MONTGOMERY COUNTY PLANNING BOARD

MEMORANDUM

REVIEW TYPE: Site Plan Review
CASE #: 82003023A
PROJECT NAME: Gateway Commons
APPLYING FOR: Continuance of the Site Plan Amendment 820030230 for minor revisions to the Site Plan

ZONE: R-200/TDR-7
LOCATION: Southwest quadrant of the intersection of Stringtown Road and MD 355 (Frederick Road)

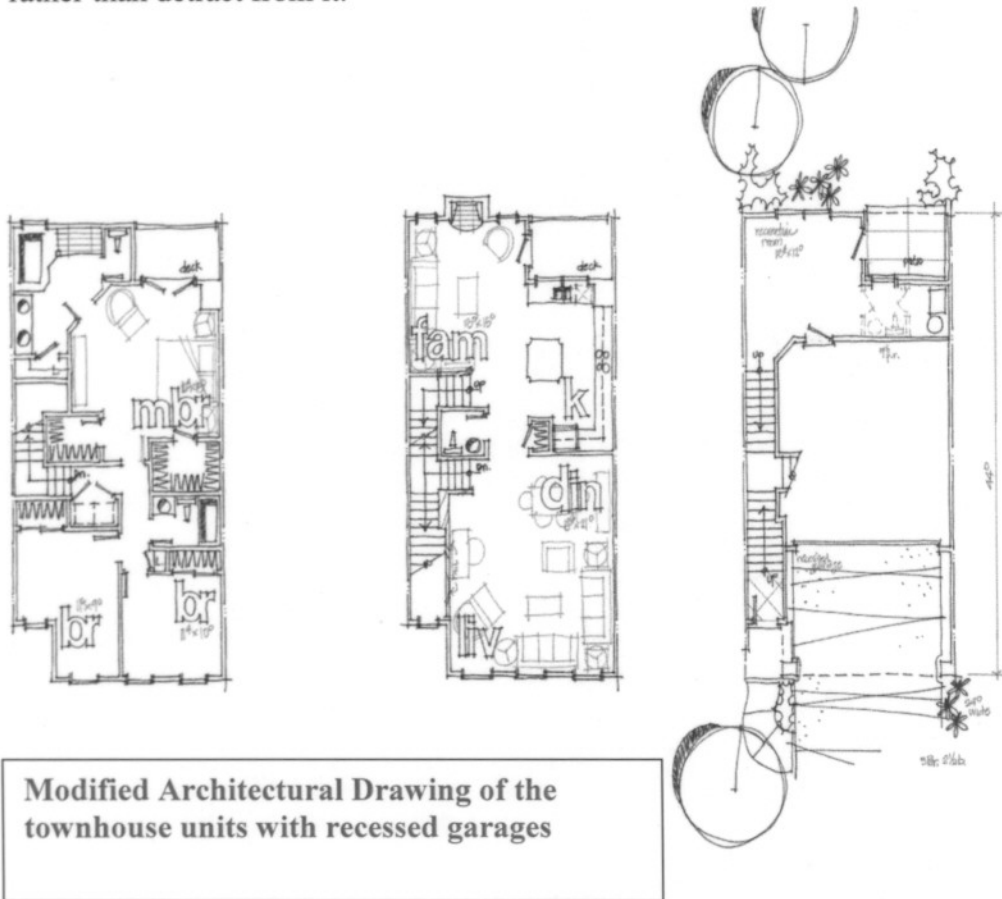
The Planning Board expressed concerns over the lack of a streetscape for the units fronting Latrobe Lane (private) as a result of the elimination of the median required

Based upon comments from the Planning Board during the December 14, 2006 hearing, the Applicant proposes reducing the total paved area on Latrobe Lane from 36 feet to 24 feet. The proposed amendment sought to eliminate the median along Latrobe Lane (private), which resulted in a significant increase in the amount of paved area and elimination of trees. The reduction of pavement provides additional yard area in front of the units along Latrobe Lane and street tree planting. The landscaping in front of the units compensates for the loss of trees in the previously approved median.

Staff Position and Recommendation

Staff finds that the reduction of pavement coupled with the addition of street trees in front of the units provides a better relationship of the units to the street. Staff recommends approval of the changes to the street and inclusion of street trees to compensate for the loss of trees within the median. The Applicant received approval from the Fire Marshall for the modification to the street on January 3, 2007.
